Delegated Report

Householder Planning Application

Planning Application No: 20230001

Location: 10 Brenchley Avenue Gravesend Kent DA11 7RQ

GB Highways Officer:

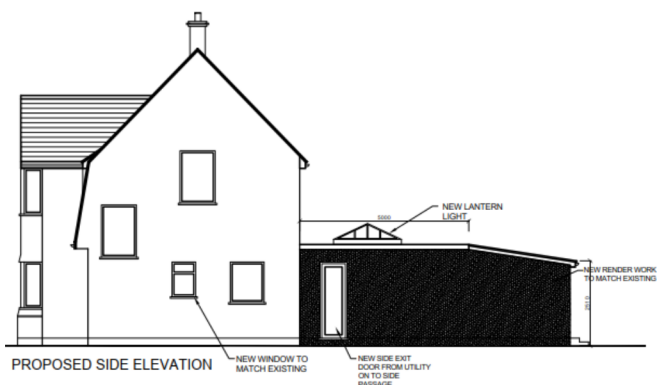
All parking spaces must have a dropped kerb. So, the provision of the access, including the carriage crossover becomes a pre commencement condition. For Kent to approve a carriage crossover, there needs to be 6 metres depth in front of a door. To comply with SPG4, one parking space adjacent to the boundary should be 2.7 metres whilst the other would be 2.5 metres.

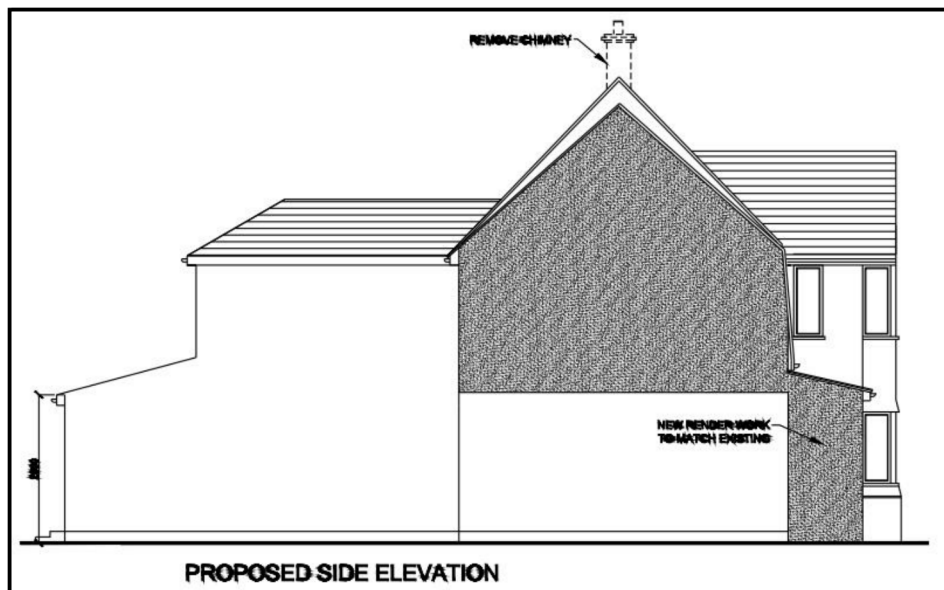
The existing dwellinghouse is a three-bedroom property. The proposed extension would result in four

bedrooms. A kitchen/diner, lounge, garage, office, lobby and WC at ground floor and four bedrooms, two ensembles, a bathroom and hallway to the first floor.

The rooms are expected meet the required minimum space standards and continue to have adequate rear garden depth and area as per SPG2 - Residential layout guidelines including Housing Standards Policy Statement October 2015 Adopted 1996 – amended June 2020.

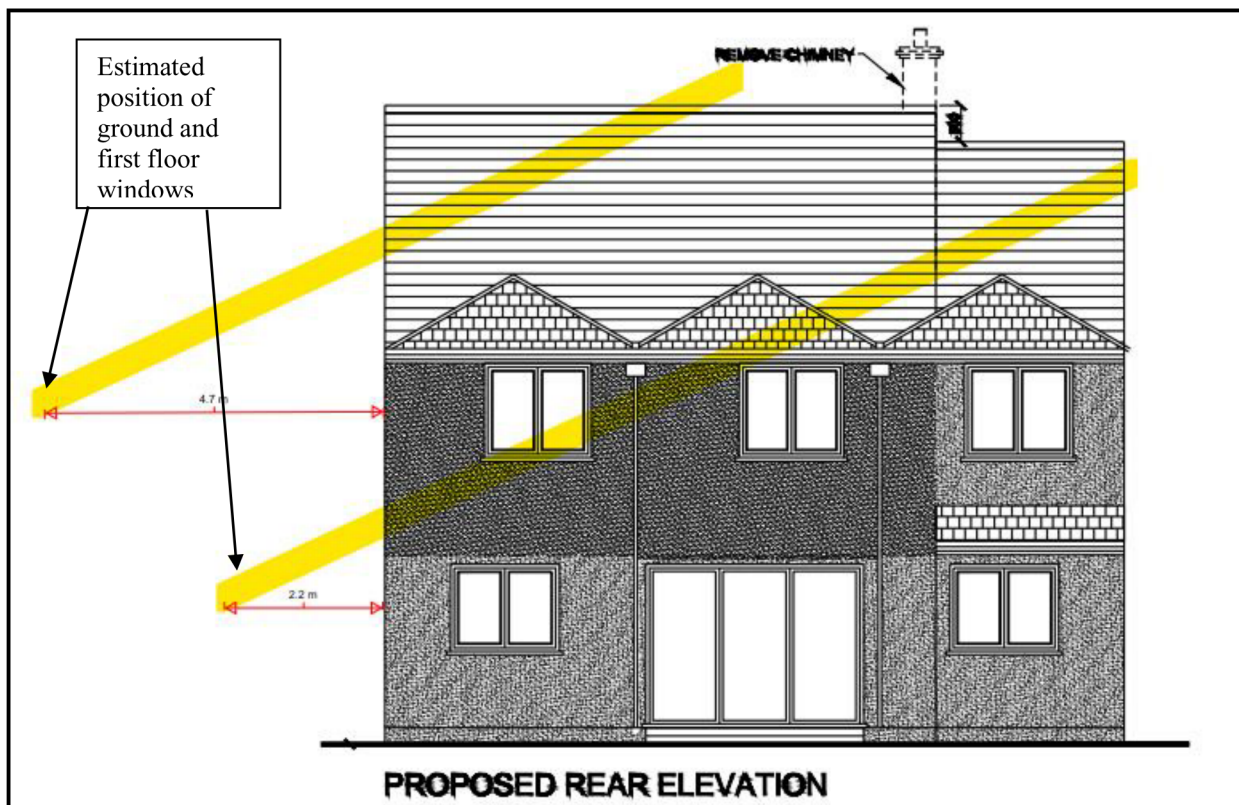
As the below images show, there are a number of openings on the side elevation of the neighbour's property with potential to be overshadowed as a result of the two-storey rear extension:

The highlighted yellow line in the above image shows the likely areas of overshadowing from the new development, using a 25-degree test. The first-floor window would likely not be significantly overshadowed, but the ground floor window would. However, as the below elevation taken from the neighbours planning application ref 20010469 shows, there is another window serving this room to the rear, which given that the proposed extension would not front this window, would not be overshadowed.
